**METROPOLITAN GOVERNMENT OF NASHVILLE AND DAVIDSON COUNTY**

**STAFF RECOMMENDATION**  
**SR 301 S 10<sup>th</sup> Street, 1004 Fatherland Street**  
**April 15, 2015**

**Application:** New construction – infill  
**District:** Lockeland Springs-East End Neighborhood Conservation Zoning Overlay  
**Council District:** 06  
**Map and Parcel Number:** 08313012500  
**Applicant:** Mark Sanders, Martin Corner GP  
**Project Lead:** Sean Alexander, sean.alexander@nashville.gov

*(Buildings "A" + "B" identical)*

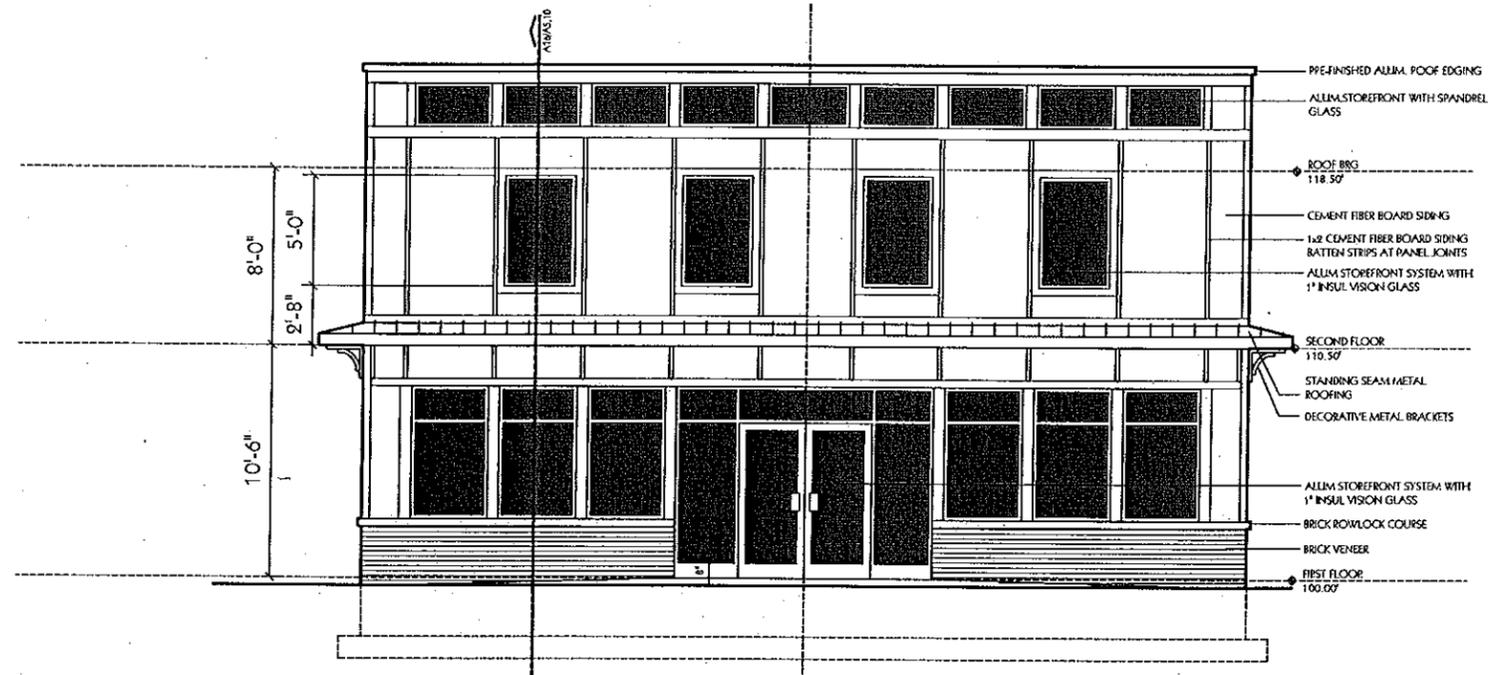
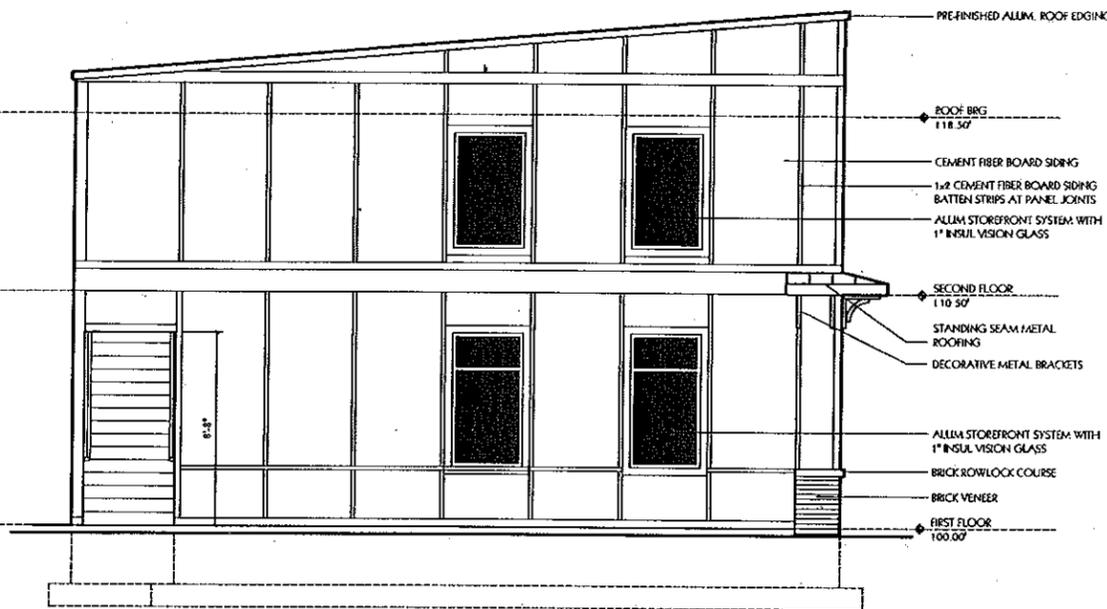
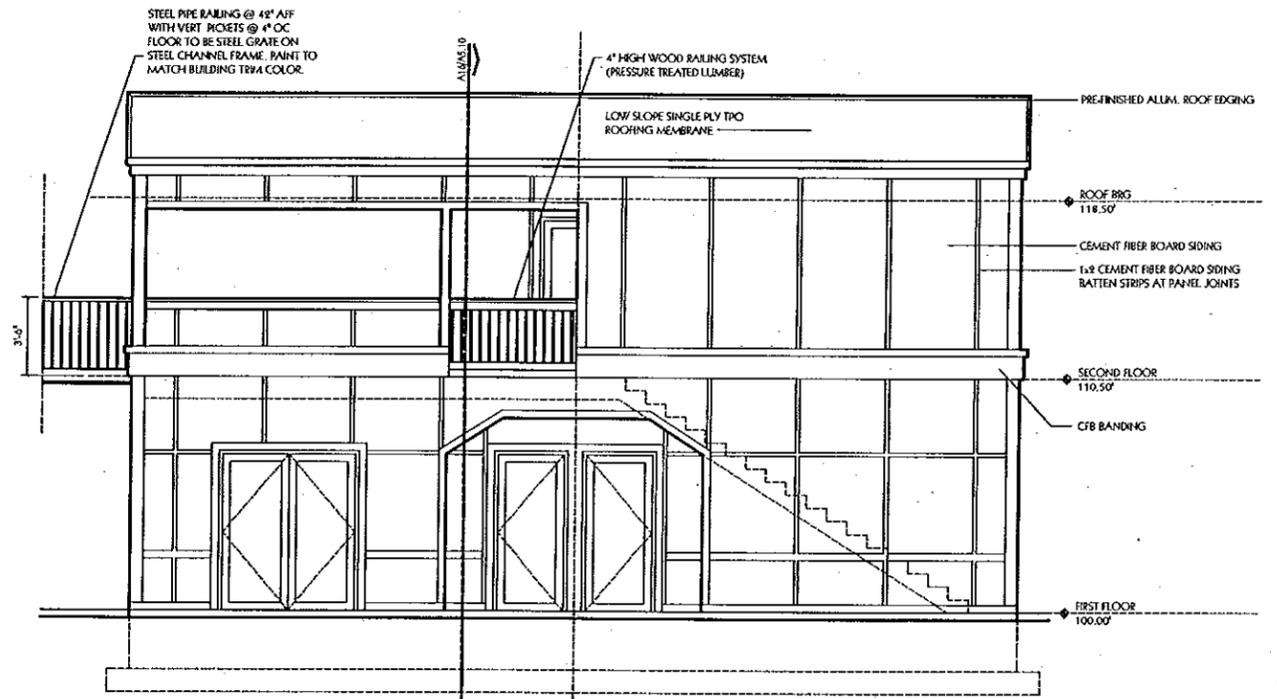
Height, Scale: All three buildings will be very similar in scale: two-stories tall with a first story cornice at ten feet, six inches (10'-6") above the sidewalk, and a maximum height of twenty-three feet (23'). These heights are consistent with historic commercial buildings in the area. The two buildings facing Fatherland Street will be forty feet (40') wide, the side walls extending thirty-four feet, six inches (34'-6") to the rear. The third building will have a fifty-four foot (54') wide primary elevation facing South 10<sup>th</sup> Street, with similar thirty-four foot, six inch (34'-6") side elevations.

Staff finds the height and scale of the buildings to be compatible with the surrounding context, including historic buildings and a commercial development on the adjacent parcel which the Commission approved in 2012. Staff finds the proposal to meet sections II.B.1 and II.B.2 of the design guidelines.

Materials: The primary exterior material for the three new buildings will be cement-fiberboard panels with battens or half-timbering at the seams. The fronts of the buildings will have brick bulkheads and metal storefront cornices with metal brackets. The windows and doors will be the aluminum storefront. These materials are identical to those on the recent development on the adjacent parcel which, in turn, are contemporary

Roof Shape: The roofs of the buildings will have a 1:12 pitch, sloping down toward the rear. This roof form resembles the typical flat roof with parapet of a historic commercial building. Staff finds that the proposal meets guideline II.B.5.

Rhythm and Proportion of Openings: The front facades will have storefront windows spanning the first stories, with vertically-oriented rectangular windows evenly spaced across the upperstories. The building at the corner will have a similar pattern of windows on both street-facing facades. The remaining side elevations will have only vertically-oriented rectangular windows, which are appropriate for secondary facades. Staff finds that the rhythm and proportion of windows on the proposed new construction is compatible with the surrounding context and that the proposal will meet guideline II.B.7.
